ExQ2: 03 August 2021**Responses due by Deadline 7: 03 September 2021**

ExQ2	Question to:	Question:
R.2	Radiological considerations	
R.2.0	The Applicant, ONR	Nuclear Site Licence (i) Please advise on the latest position in respect of the application for the nuclear site licence. (ii) Are you aware of any impediment that may exist that would prevent or delay the granting of the licence? (iii) What is the current timetable that you would anticipate for the conclusions upon the license application being reached?
	SZC Co. Response at Deadline 7	SZC Co. submitted the Nuclear Site Licence (NSL) application in June 2020 and is actively engaged in all regulatory workstreams. Workstreams are monitored routinely via joint Level 3 and Level 2 meetings with the Office for Nuclear Regulation (ONR). The purpose of these meetings is to discuss the route and progress towards achieving a NSL in 2022 aligned to a schedule agreed with the ONR. The ONR's programme of regulatory interventions has been defined and is being delivered to support the licensing process and to meet the anticipated licensing timeline. SZC Co. is confident that the plant design is sufficiently mature and the organisation will

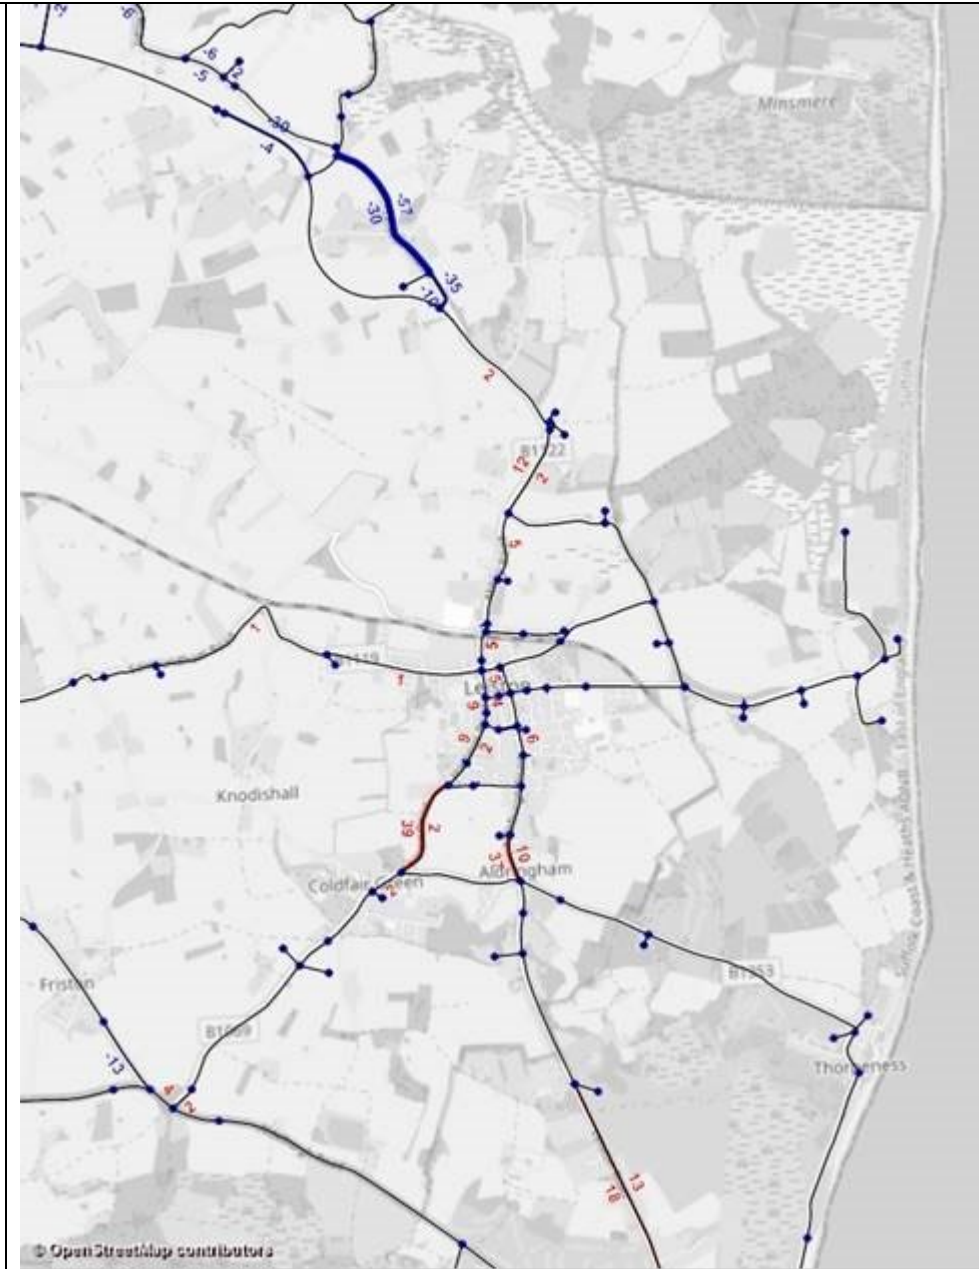
TT.2.29	The Applicant	<p>Outage Car Parking – Transport Assessment There was discussion at ISH5 about the permanent provision of two outage car parks, one each for Sizewell B and C. Following that discussion and taking into account comments made by Suffolk County Council [REP5-171], explain why it is considered that a double outage is considered so likely that it meets the criteria for exceptional circumstances in paragraph 5.9.10 in NPS EN-1, but it has not been assessed in the operational stage within the Transport Assessment. A double outage could have significant effect on operational traffic generation and the assessment of impacts undertaken. Should such a scenario not be considered by way of a sensitivity test of the assessments?</p>
	SZC Co. Response at Deadline 7	<p>The Consolidated Transport Assessment [REP4-005] seeks to assess a core scenario for the Sizewell C Project for different stages of the project. The assessment includes a reasonable level of robustness but, in accordance with WebTAG guidance, does not seek to create a 'universal worst-case scenario that takes into account all risks' (TAG Unit M1).</p>

ExQ2	Question to:	Question:
		<p>The Consolidated Transport Assessment [REP4-005] was scoped with Suffolk County Council as the local highway authority and an assessment of an unplanned outage with a planned outage was not required by SCC as part of the core assessment scenario. Notwithstanding this, there is a risk that a planned outage at Sizewell B could coincide with an unplanned outage at Sizewell C or vice versa and therefore separate outage car parks are proposed for each facility. Consideration has therefore been given in this response to the scale of traffic that that scenario would generate and whether it would result in new transport effects. A summary of this sensitivity assessment is provided below.</p> <p>A review of traffic flows across selected links close to the study area has been undertaken in the 2034 Operational phase to establish whether there would be any links with a substantially higher flow than has already been assessed in any hour, in either the 2034 Operational or the 2028 Peak Construction phase. Beyond this local study area the assessed 2028 Peak Construction traffic flows would be higher than traffic flows generated by a double outage.</p> <p>The 'Sizewell B outage' traffic flows on each link (which were already included in the Reference Case scenarios) have been manually added again to the total 2034 Operational phase traffic flows, to represent two outages occurring. A manual adjustment has been made to account for the fact that the Sizewell C outage car park would be accessed via the MDS roundabout on the B1122, rather than the Sizewell B access on Sizewell Gap.</p> <p>The assessment was undertaken for each link as follows:</p> <ul style="list-style-type: none">• The maximum flow in any of the seven modelled hours, in the 2034 Operational 'double-outage' scenario, was calculated.• This was compared against the maximum flow in any of the seven modelled hours in either the 2034 Operational or 2028 Peak Construction scenarios.• The difference between these two maximum flows on each link is presented graphically on the network diagram below (blue numbers are negative representing a decrease from what has already been assessed and red are positive representing

ExQ2	Question to:	Question:
		<p>an increase from what has already been assessed). This demonstrates where traffic flows in the 2034 Operational phase, with a double-outage, could potentially be higher than any scenario already assessed within the DCO (red numbers within the diagram).</p> <ul style="list-style-type: none">• The diagram shows that there would be reductions in traffic on the B1122 and SLR compared to what has already been assessed. The diagram shows that around the local study area in Leiston the addition of an outage at Sizewell C as well as Sizewell B would not result in significantly higher traffic flows than has been assessed already as part of the DCO. The diagram shows the following increase in flows in the Leiston area compared to what has already been assessed:<ul style="list-style-type: none">- B1122 north of MDS roundabout +2 two-way veh/hr- Abbey Road south of MDS roundabout +14 two-way veh/hr- Abbey Road south of Lover's Lane +5 two-way veh/hr- B1122 Aldeburgh Road +6 two-way veh/hr in Leiston, +13 two-way veh/hr at Aldringham and +31 two-way veh/hr between Aldringham and Aldeburgh- B1069 in Leiston +11 two-way veh/hr, +41 two-way veh/hr north of Coldfair Green, +2 two-way veh/hr south of Coldfair Green- A1094 at the junction with B1069 +2 to +4 two-way veh/hr <p>The maximum increase in traffic generated by a double outage compared to the highest flows already assessed is +41 veh/hr north of Coldfair Green, which is less than 1 veh per minute increase.</p>

ExQ2	Question to:	Question:
		<p>It is therefore concluded that the scale of traffic generated by coincident outages would be less than the traffic which has already been assessed for the vast majority of the links. Where there would be increases in traffic these would be less than 1 two-way vehicle per minute and for a short-term period during the length of the double outage. It is therefore considered that no further mitigation is required beyond what is already proposed by SZC Co.</p>
